Development Code Updates

Receive a staff presentation and hold a Public Hearing to receive comments for or against Ordinance 2021-XX, on the first of two readings, amending the San Marcos Development Code, that, among other things, would address typographical and technical errors, and implement changes related to site permit requirements, detention, stormwater quality and stream protection, residential garage and pedestrian access requirements, building activation, the use of self storage and outdoor storage, the Employment Center zoning district, allowable uses in CD-2.5, ND-3.2, and other revisions to the Land Use Matrix and provide direction to Staff.

Overview of Proposed Amendments

New Graphic

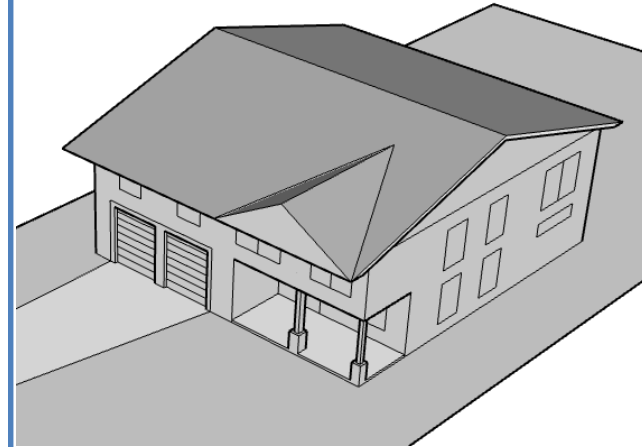
Purpose: Revises the garage standards to allow for a garage to be flush with the front façade or front most protrusion of a house.

- a. **Flush.** Garage is attached to the primary structure and where the garage doors are oriented to the street.
 - 1. In no case shall the garage be the front-most protrusion of the front facade of the house.
 - 2. The garage may be flush with the front façade of the house or a covered front porch. Where a porch is provided, the standards in section 4.3.5.11 shall apply.
 - 3. The total width of the garage door (including any center column between two garage doors) shall not exceed more than 55% of the width of the façade in which the garage is placed.
 - 4. A single garage door shall not exceed 16' in width. If two garage doors are proposed, each garage door shall not exceed 8' in width.

Updated Graphic

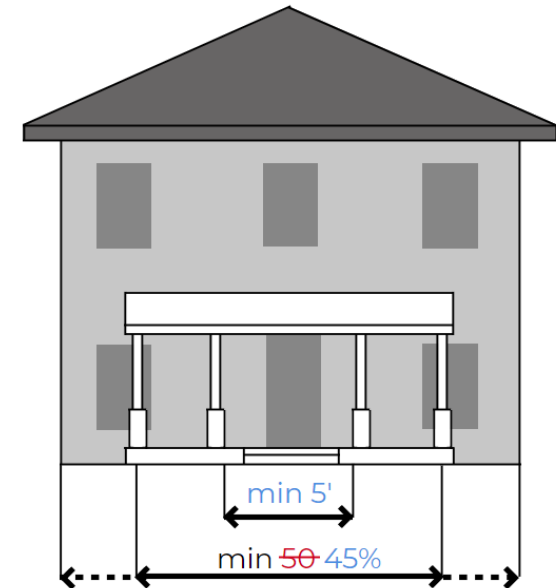
Purpose: Relates to the residential garage requirements and provides a minimum area for installing a front porch.

1. A front porch must be at least 6 feet deep (excluding the steps [and any porch posts](#)).
2. [A front porch shall have a minimum area of 50 square feet.](#)
3. [Front porch posts which flank the front door, entry, or access point to the unit shall be separated a minimum of 5'.](#)
4. A front porch must be contiguous with a width not less than ~~45~~ 50% of the building facade.
5. A front porch must be roofed and may be screened but cannot be fully enclosed.
6. A front porch may extend up to 9 feet, including the steps, into a required front setback, provided that such extension is at least 2 feet from the vertical plane of any lot line.

New Graphic

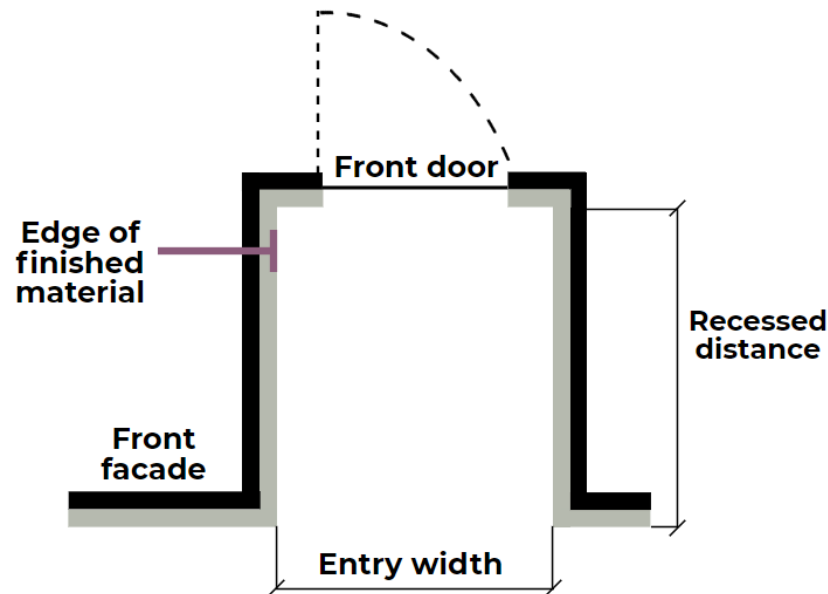
Purpose: Creates a new standard for residential front door entrances to enhance visibility and assist first responders. Reflects Police recommendations.

Scenario #1: If the front door is recessed 3 feet or less from the front façade, the entry shall be a minimum of 5 feet wide for the entire length of the entry.

Scenario #2: If the front door is recessed more than 3 feet from the front façade, the entry shall be a minimum of 7 feet wide for the entire length of the entry.

- No architectural obstructions that reduce the passable width of the entry
- Measured from edge of finished material
- If front porch is proposed, see Section 4.3.5.11

FIGURE 7.2 SEMI-FLUSH GARAGE

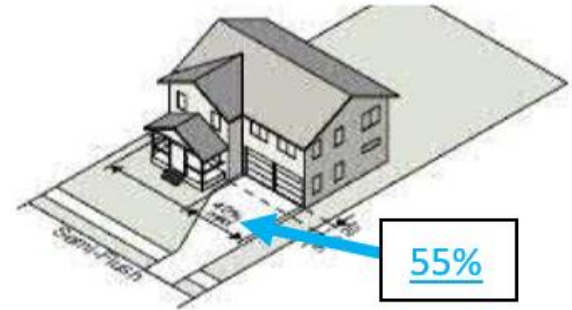
1. That staff and City Council look into bringing Planned Development Districts back into the Development Code.
2. Amendment #5 to revise Section 7.1.4.1.C.1.b. Semi-Flush, to increase the allowable percentage that garage doors can extend on the width of the house from 40% to 55%.

b. Semi-Flush. Garage doors are oriented toward the street. Garage doors must be positioned between 5 and 20 feet behind the front wall plane of the house, extending no more than ~~40~~ 55% of the width of the house. No individual garage door may exceed 12 feet in width.
